Applic. No.: 10/631,356
Amtd. Dated February 2, 2006
Reply to Office action of November 2, 2005

REMARKS/ARGUMENTS

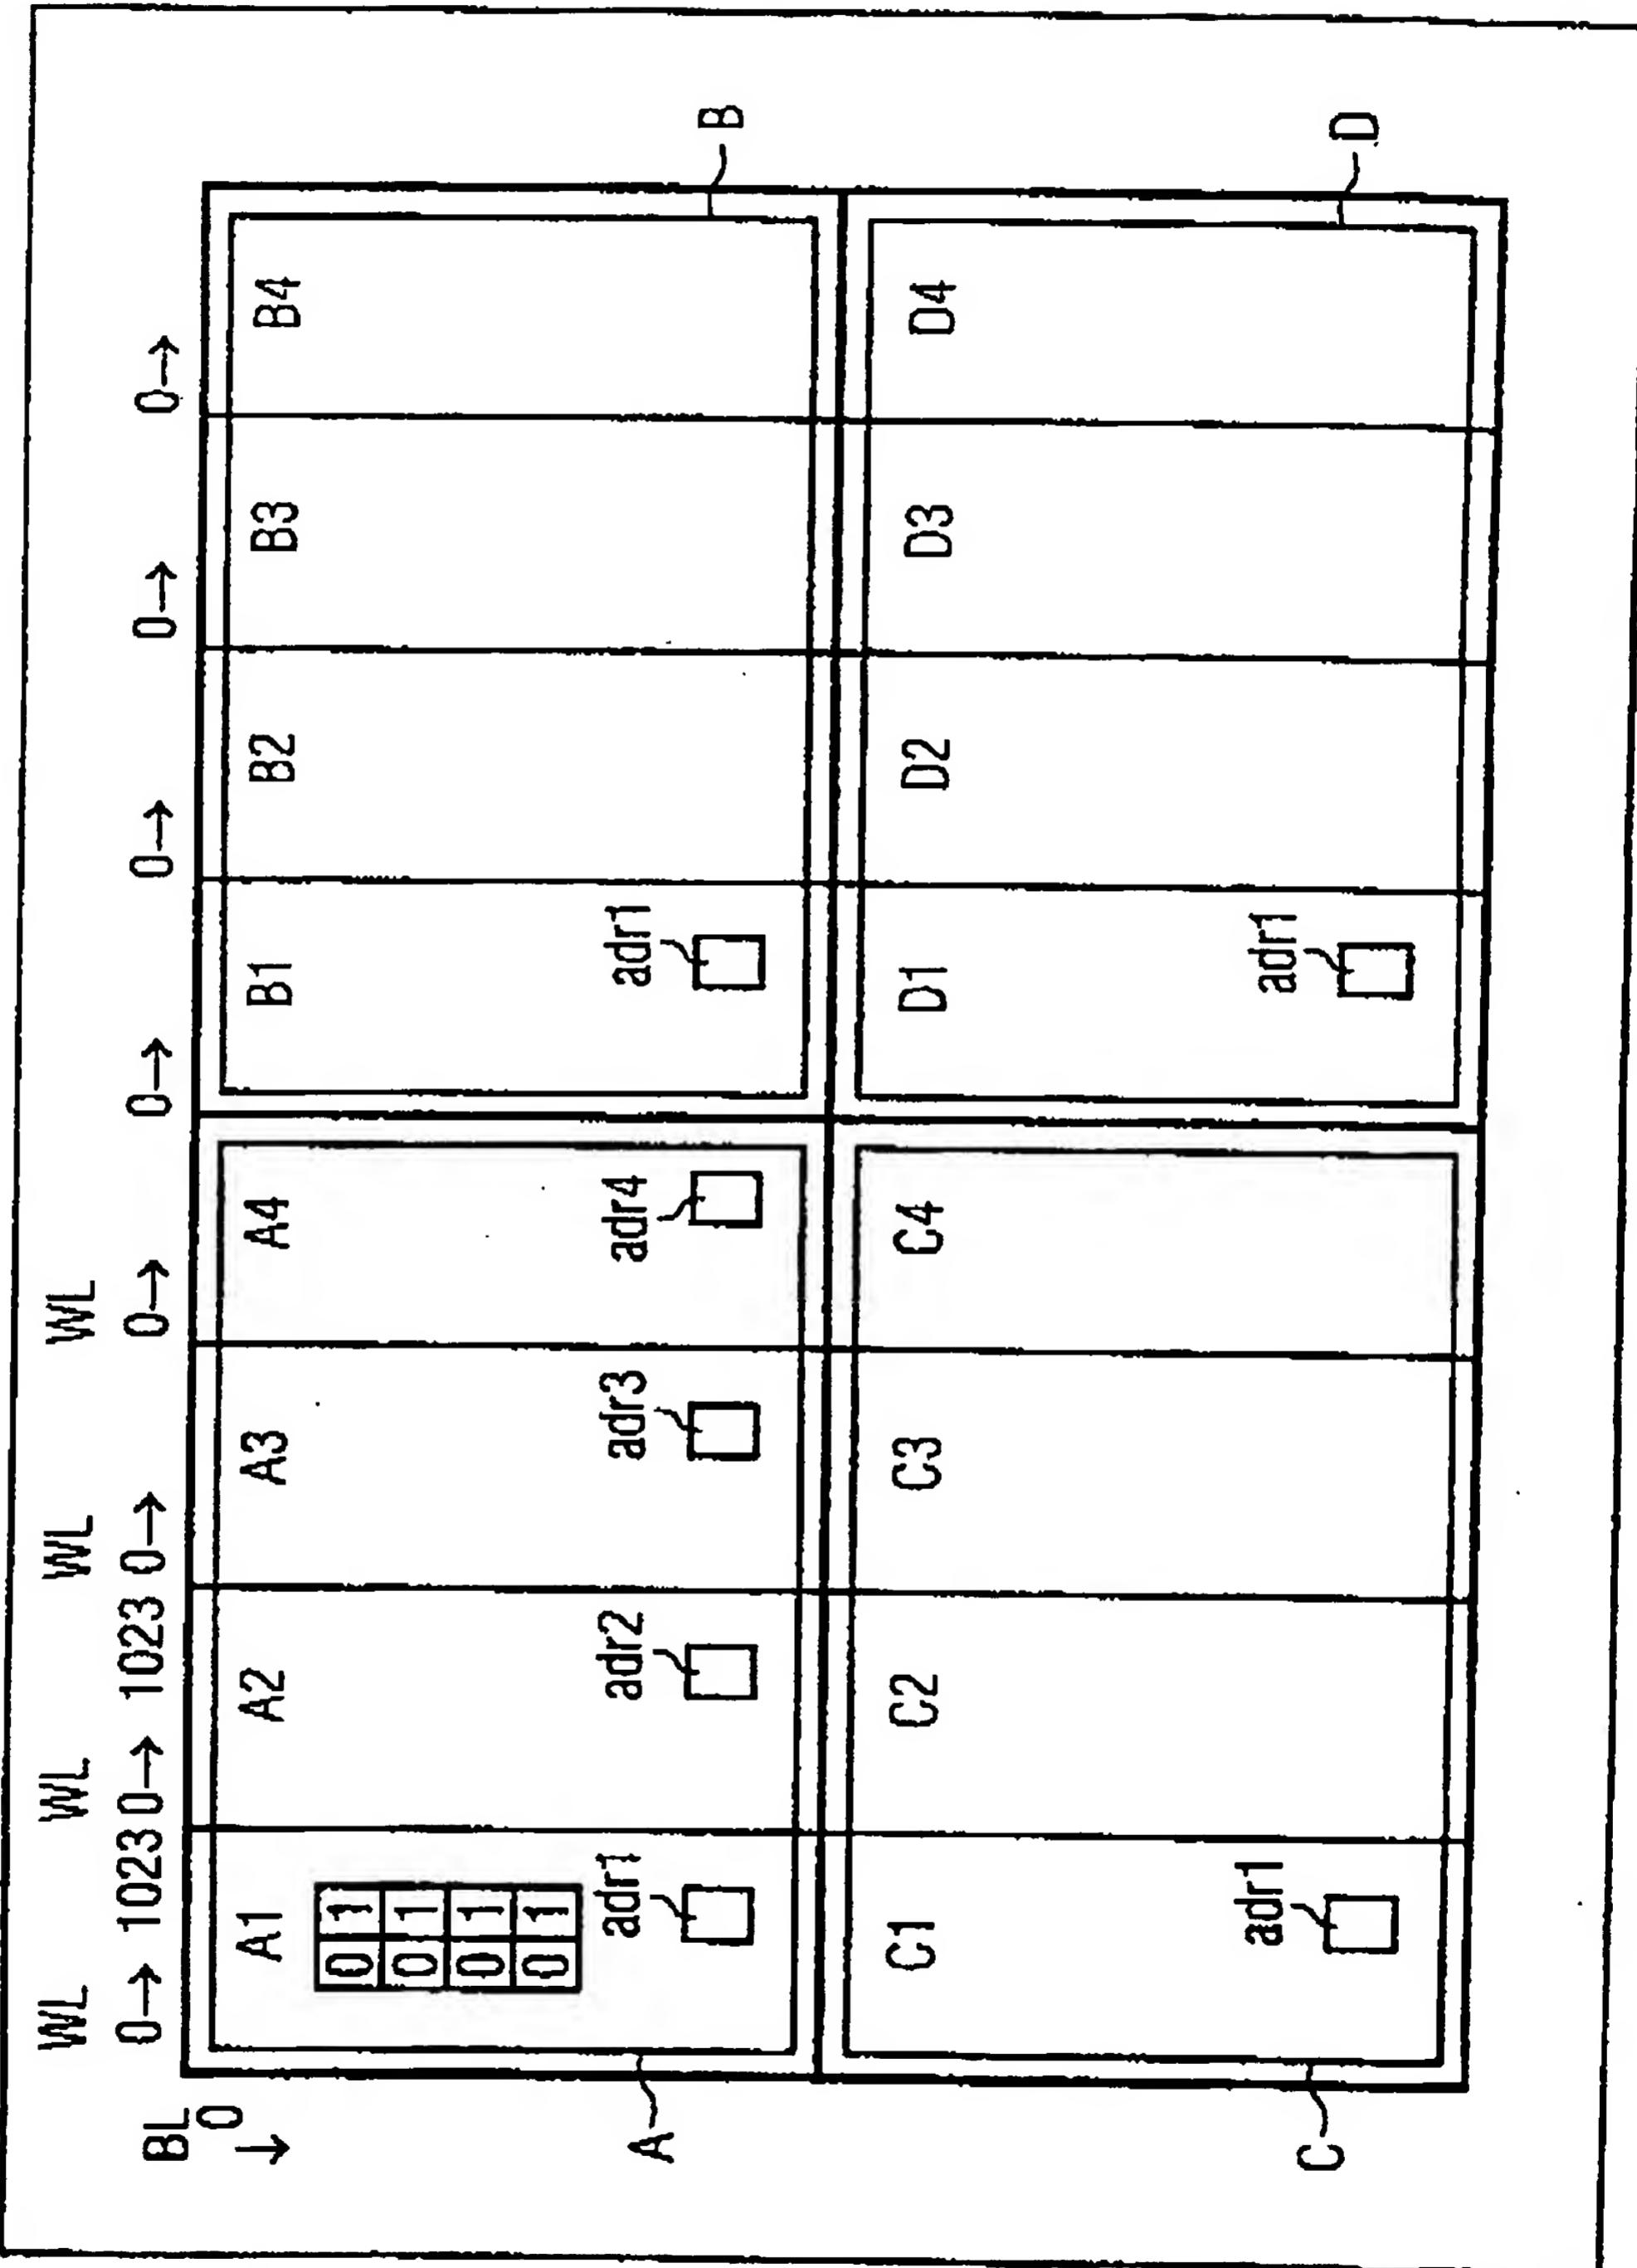
In item 1 on page 2 of the above-identified Office action, the drawings have been objected to under 37 CFR 1.83(a) as not showing every feature of the invention specified in the claims.

More specifically, the Examiner has stated that the method steps:

defining a plurality of subareas...;
using first commands for accessing a first subarea ...
and second commands for accessing a second subarea ... to
form, ..., a compressed command sequence, ...; and
writing and/or reading the information by executing in
all of the memory banks ..., must be shown or the feature(s)
cancelled from the claim(s).

Fig. 6 has been added to show the above-mentioned method steps. The specification has been amended accordingly. Also, it is noted that it is clearly shown in Fig. 3 that a

plurality of subareas (A1, A2, A3, A4; B1, . . . B4; . . ., D4)
are defined in each of the memory banks (A, B, C, D).
